Subject: Transportation Consulting Services  
Proposed Retail Development, 190-198 Hartford Avenue  
Bellingham MA

MDM Transportation Consultants, Inc. (MDM) is pleased to provide you with the following initial transportation review comments for the above-referenced project. These comments have been prepared based on field review of the site and review of the documents identified below. To facilitate response by Applicant, review items requiring response are noted in ***Bold Italic***.

# Concrete Island Detail Example (Can be replaced by non-scored concrete)

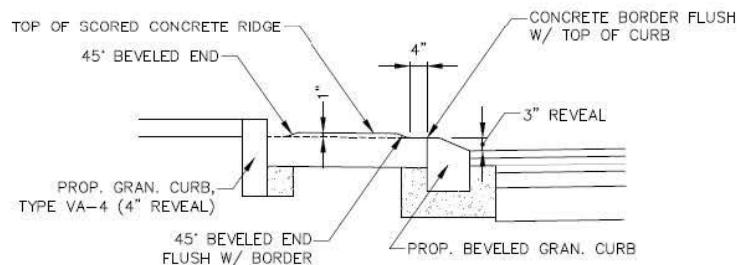
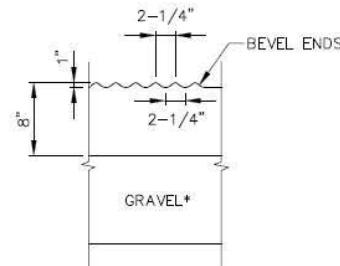
- *As discussed with Fire Department, Planning, Police and Public Works in an Applicant working session, the Cedar Hill Road design should include a mountable island feature to prevent through traffic into the Cedar Hill Road neighborhood; as currently shown, this design feature is flush scored concrete. A suggested design would include mountable granite curbing with 3-inch height and concrete surface that facilitates emergency apparatus travel but provides a positive physical deterrent to passenger vehicles. Refer to attached typical detail for reference which may be modified to replace scored/textured concrete with a smooth concrete surface.*
